Product Change Notification

Product Change Notification: PCN-22-133688

General Product Description:
D2100 REC HOUSING

D2100 REC Housing's appearance difference of new & existing tool

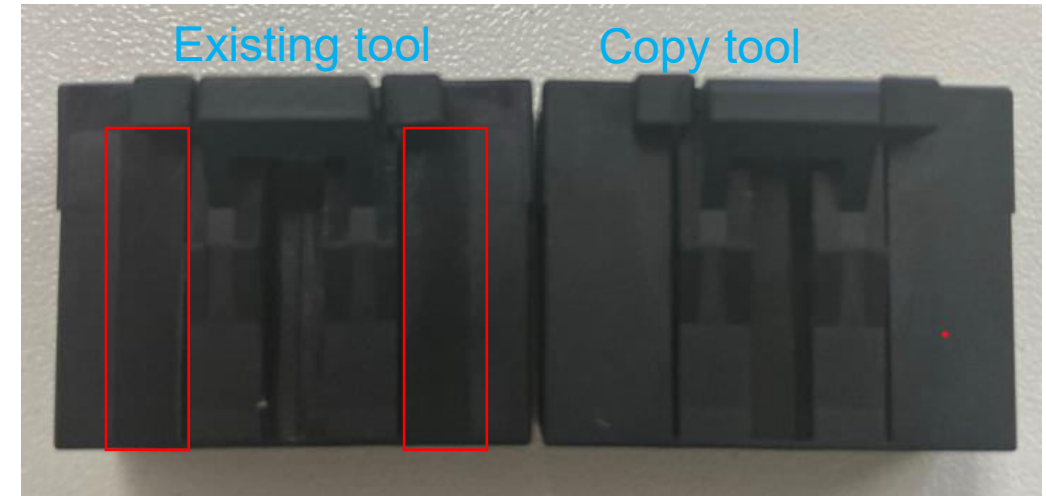
Description of Changes
A minor appearance change for process optimization without any performance impact. PN:1-1318118-9/2-1318118-9/3-1318118-9/9-1318118-9 ,Because the new and old molds will be produced at the same time, the two appearance products will exist at the same time Before Two Sink mark in latch face & without two Square holes in Terminal insertion face After Add two Square holes in Terminal insertion face to improve Sink mark in latch face As annex
Other attachments:
[D2100 REC Housing's appearance difference of new & existing tool](#)

As the red mark, Two square holes are added to the copy die for solve the problem of product sink mark.

As the red mark, sink mark of molding before change
